DeKalb County Historic Preservation Commission

Monday, April 15th, 2024- 6:00 P.M.

Staff Report

K. 1095 Lullwater Road, Eric and Lynne Segall. Replace front walkway and install new gate.
1246966

Proposed Front Walkway & Landing

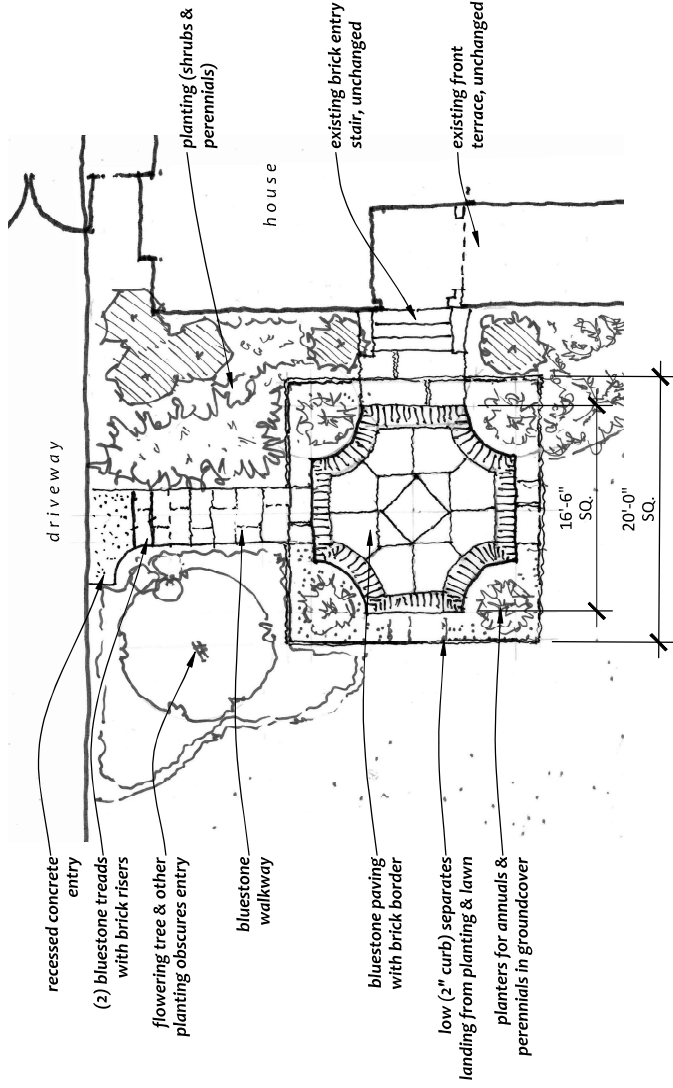
Approve with Modification. The applicant may install the proposed hardscape but may not install other landscaping until a list of plantings is provided. When providing a list of plantings, it is recommended that a screening be included in the landscape plan to mitigate the appearance of the hardscape.

1. What are the proposed plantings for the landscaping? Please refer to the list of historically appropriate vegetation in the Druid Hills Design Guidelines if necessary: <http://www.dekalbcountyga.gov/sites/default/files/user348/Section%20009.pdf>
2. What is the height of the proposed gate?
3. Will the gate be automatic or self-latching?

Attached is a letter from my landscape architect, Spencer Tunnell of Tunnell & Tunnell. As I mentioned in a note last night, we have not finalized the front yard plantings yet. We are seeking the CoA on the new front walk so we can contain costs by having the masons do that work on the front while they are on site working on the existing renovation to the house. We are happy to come back in a few months when we have the front yard plans finalized for another CoA on that if that is required.

Surrounding the new bluestone landing will be a low growing groundcover. The Owners are deciding between Creeping Thyme, Dwarf Mondo grass, and White Thrift (*Phlox subulate*). The four corners of this space will be anchored with annual color to include Petunias, Verbena, and Creeping Thyme.

Between the stairs that replace poorly functioning and cracked steps by the driveway, will be a bed of Asiatic Jasmine and a small scaled native flowering tree. The Owners are still deciding between a Flowering Dogwood, Redbud, or Serviceberry.
